Re: FortisBC Energy Inc. (FEI)

Application for a Certificate of Public Convenience and Necessity (CPCN) for the Okanagan Capacity Upgrade (OCU) Project (Application) ~ Project No. 1599152

Response to the Commercial Energy Consumers Association of British Columbia (CEC) Information Request (IR) No. 1 on Supplementary Filing

Figure 2-1: Supplementary Filing Peak Demand Forecast

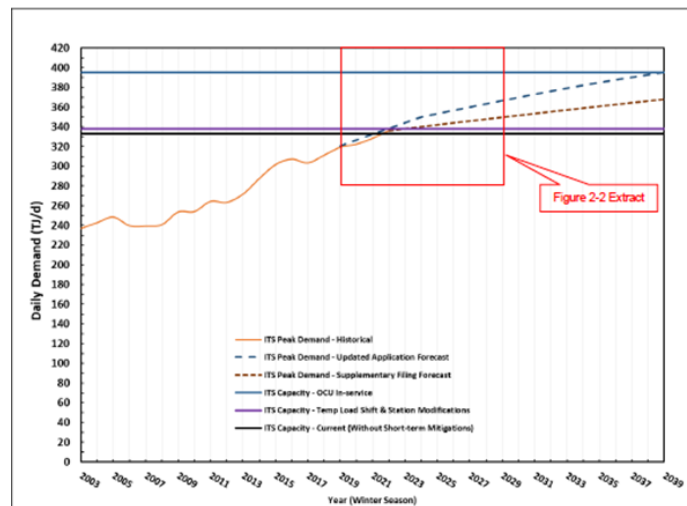
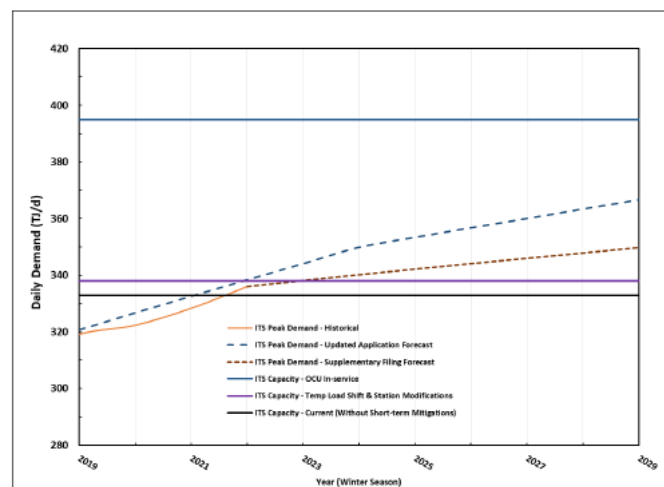
1.1 Please provide the data for the peak demand forecast in table form.

1.2 As noted in FEI's document, the peak demand forecast is significantly lower than that used in the updated Application. Please provide FEI's understanding of the reasons for the change in FEI's peak demand forecast.

1.4 To the extent that FEI's future forecasts offer continuing declines in peak demand growth, would it be reasonable for FEI to consider deferring the project?

Please refer to the response to BCUC Supplementary IR1 1.2.

Please refer to the response to BCUC Supplementary IR1 1.3.

It would not be reasonable to defer the OCU Project. As noted in the Supplementary Filing, the historical peak demand currently exceeds ITS capacity, and peak demand is forecast to increase over time. The ITS system requires an imminent capacity expansion to ensure FEI's customers continue to receive reliable service during cold weather conditions.

FEI emphasizes that, though the Supplementary Filing Forecast shows lower peak demand relative to the Updated Application forecast, both forecasts show continued peak demand growth over time.
